ADDENDUM #2

Reference: Greendale Maintenance Station Replacement
Utah Department of Transportation – Daggett County, Utah
DFCM Project No. 07029900

Subject: **Addendum No. 2**

2.4.1 The complete **drawing set has been revised and is re-issued with this Addendum.** Owner requested the deletion of the mezzanine and mezzanine access. Walls around office area extend 18'-0" A.F.F. Building footprint has been revised to incorporate larger truck bays. All drawings for all disciplines have been revised showing new building footprint & layout.

AD101

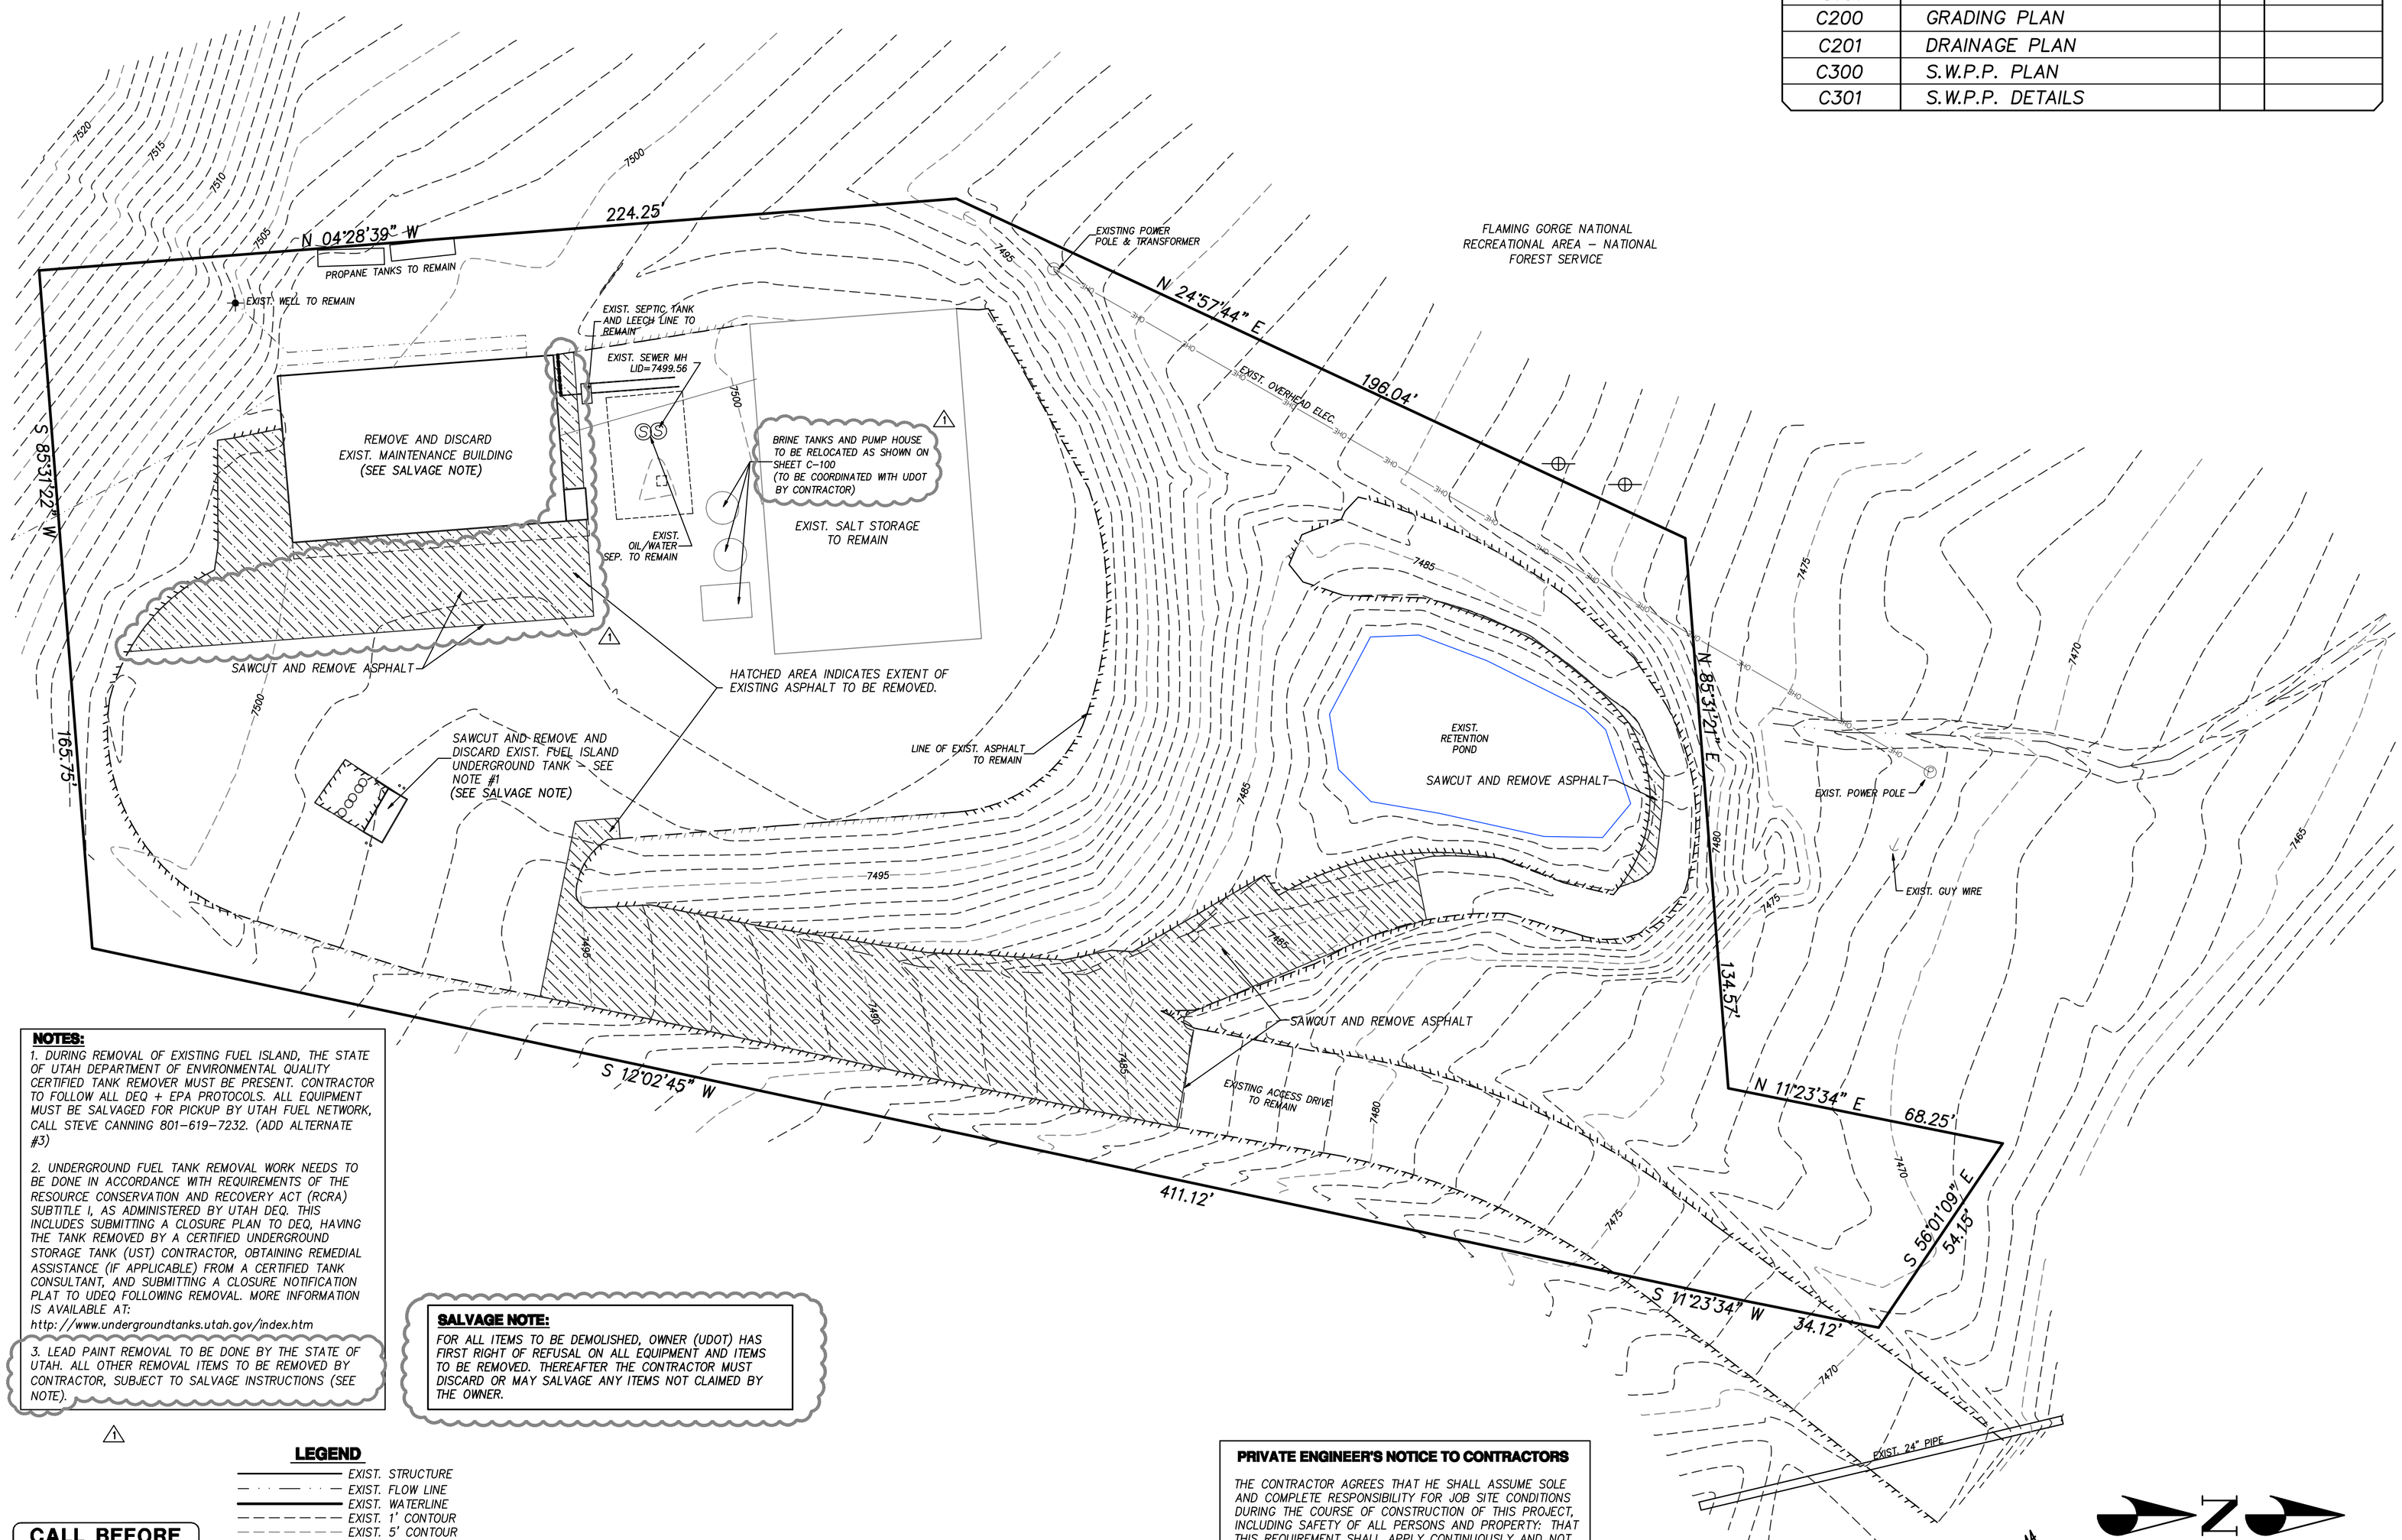
a. Area of asphalt removal and saw cut revised around existing building.
b. Note about brine tanks and pump house relocation revised.
c. Note about salvage of existing fuel island added..

C100

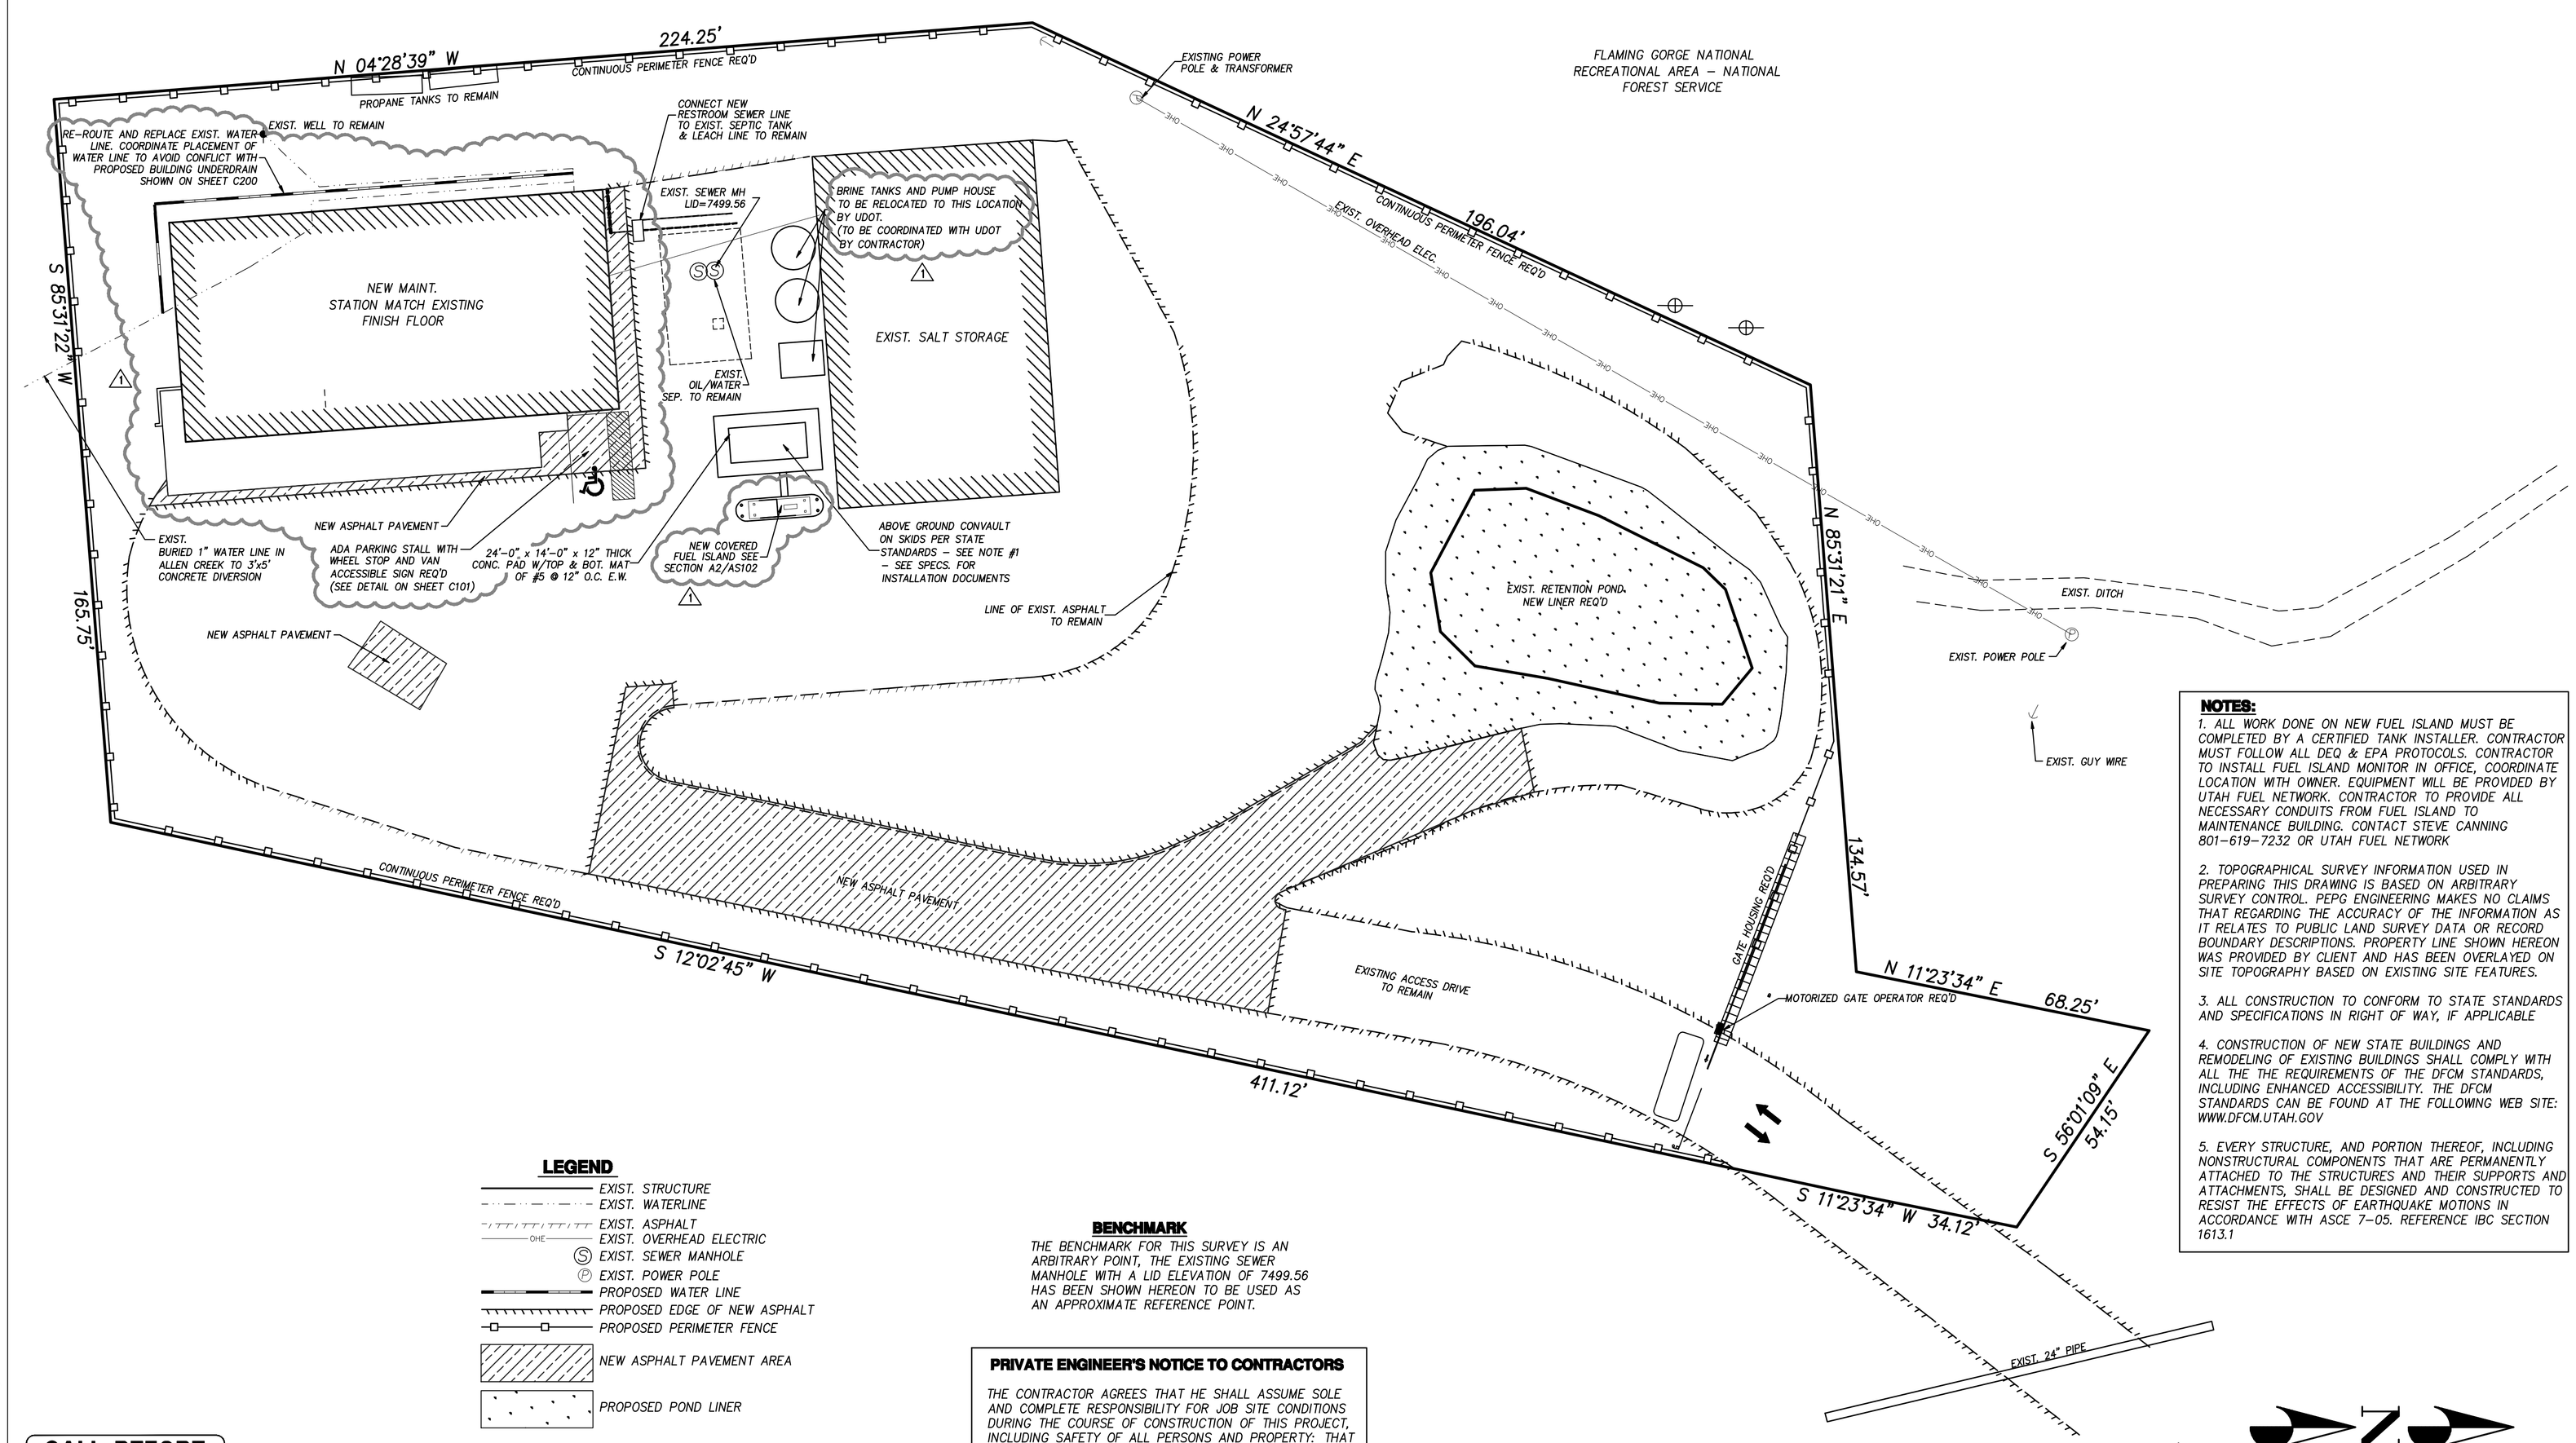
a. Revised site to show larger maintenance building.
b. New covered fuel island design and layout added.
c. Brine Tank relocation note revised.
d. General notes from DFCM added.
e. Water line that is being relocated around back of new building has been moved and extended to accommodate for the larger building and new building under drain pipe.
f. Handicap stall added.

C101

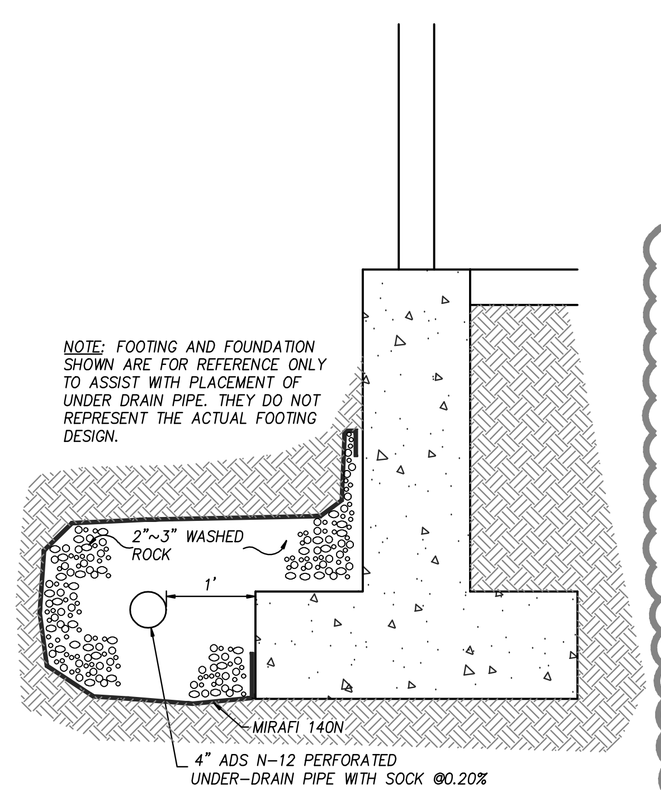
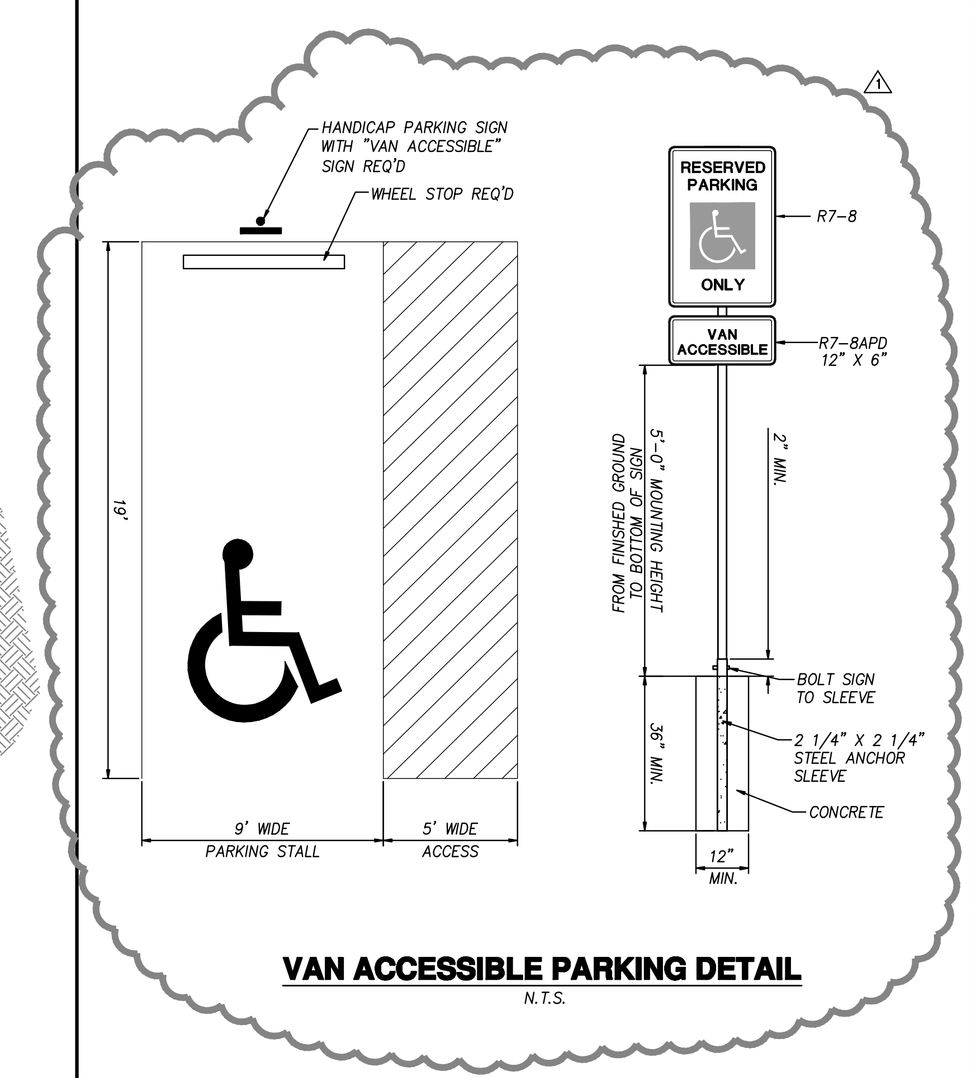
a. Building under drain detail added.
b. Handicap stall and sign detail added.
